Access Compliance Report Public Rights-of-Way (Curb Ramps)

Main Street: WALDEN_ST Cross Street: SIENNA_PKWY Location: E

ADA ID: RPRK211020173818 Ramp Type: Type 1 - Perpendicular Diagonal Initial Pass/Fail: Pass Overall Compliance: No Severity Score: 24

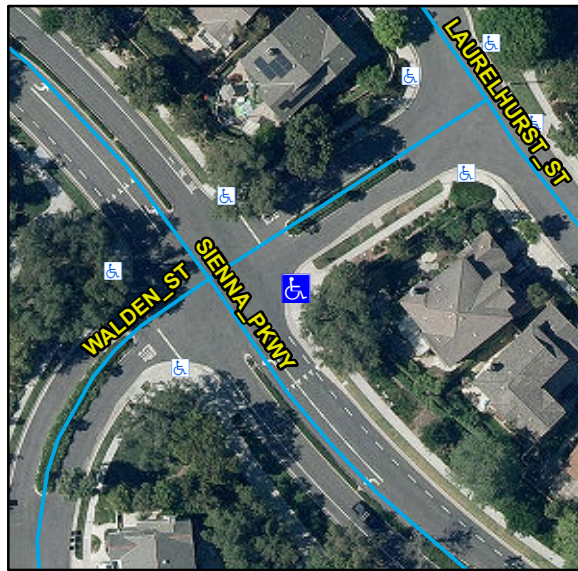
R304.2.2, R204.3, R304.2.1, R304.2.2-Perp, R304.3.2-Para, R304.5.3, R305, R304.5.4, STD 1115

N/A	Ramp Inside Crosswalk 1	N/A	Yes	Ramp Inside Crosswalk 2	N/A
	Crossing 1 Slope (%)	1		Crossing 2 Slope (%)	2.8
	Crossing 1 Cross Slope (%)	3.2		Crossing 2 Cross Slope (%)	1.2
Yes	Gutter Ponding	No	No	Curb Slope	9.3
Yes	Gutter Lip Height (in)	0		Road Run Slope (%)	2.4
No	Gutter Run Slope (%)	8		Road Cross Slope (%)	2
No	Gutter Cross Slope (%)	4.3			
Yes	Overall Surface Condition: Acceptable		No	Perp Joint Present	No
	Cross Gutter Present?	No		Spandrel Present?	No
	Replace Cross Gutter?	N/A		Replace Spandrel?	N/A

Remove & Replace Curb Ramp With Two New Directional Ramps or Equivalent. Remove & Replace Gutter.
